Product hierarchy no. *			Part no.	SBU	Type / Description	Customer part no.
SBU	PG	PGU	Type			
02	007	038	0000002289	4789.1100	Connectors	4789 Plug Connector for cable 16A
02	007	038	0000002289	4789.1200	Connectors	4789 Plug Connector for cable 16A

2 Type of change

4789					0118.2132	
creation date	created by	release date	released by	notification no.	revision	page
2012-10-02	haechlsa	2013-04-11	haechlsa	24635	b	1 of 2

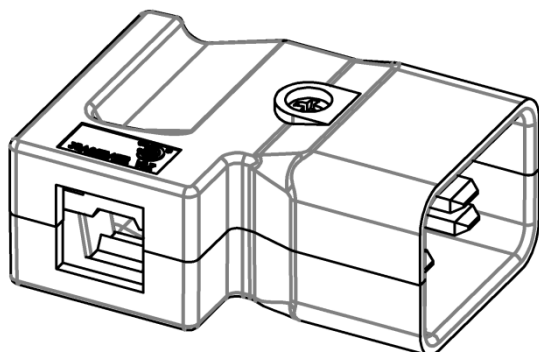
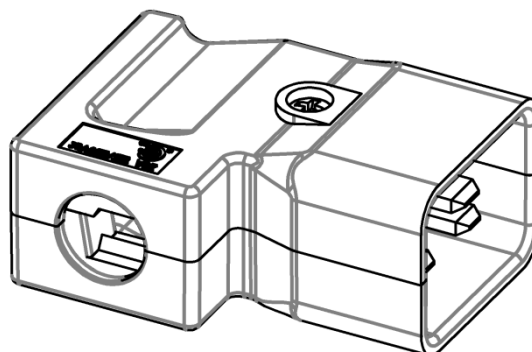
Renewal of the approval marks.
 The opening for the cable guard is new round for better holding in the housing.
 The marking UL/CSA rating 21A has changed according to UL60320 to 20A.

The opening of the housing has changed

A cable guard with square fastening groove was used

The NEW opening of the housing looks like this

NEW a cable guard with round fastening groove is used

To pass the stronger test requirements according to IEC 60320-1 (Sect. 22: Cords and their connection), flange and slot on the cable guard had to be reinforced. As there have been made new tools for the moulding parts the holding of the cable guard got improved with a round opening.
